ADDENDUM #3

Date: September 19, 2012
Project: Project 405-304, Sterile Processing and Distribution Replacement
VAMC White River Junction, Vermont
Architect: Warrenstreet Architects, Inc.

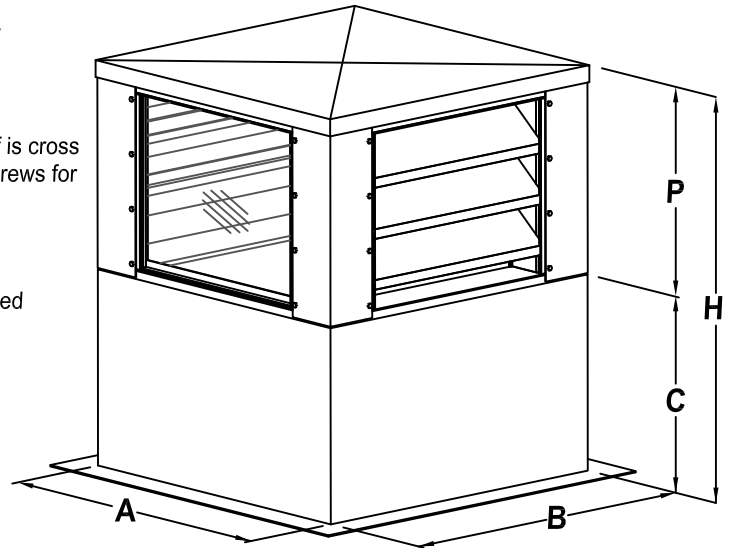
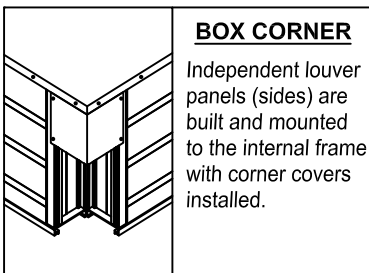
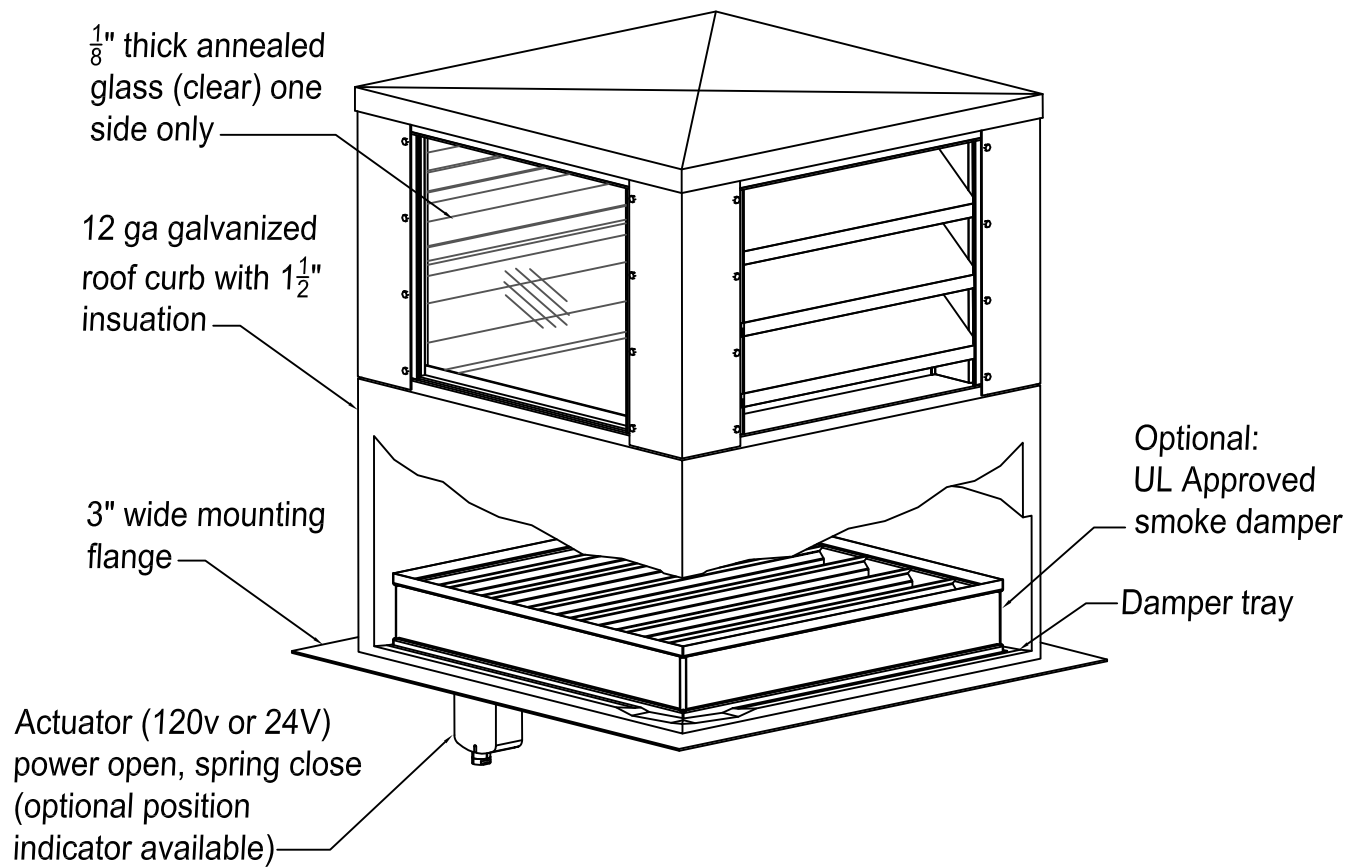
- 3.2 DWG A407, Detail 1: Provide pre-manufactured, roof mounted, elevator vent penthouse over the southwest corner of the elevator shaft for Elevator #1. Basis of design for vent penthouse to be United Enertech model PEL-4EL as outlined in attached cut sheet. Provide with smoke damper. Smoke damper to remain normally closed and operated by activation of elevator lobby or hoistway smoke detectors and by manual manual override control panel with position indicator in VA approved location. Provide steel roof frame as indicate in structural drawing S.400, detail 14.
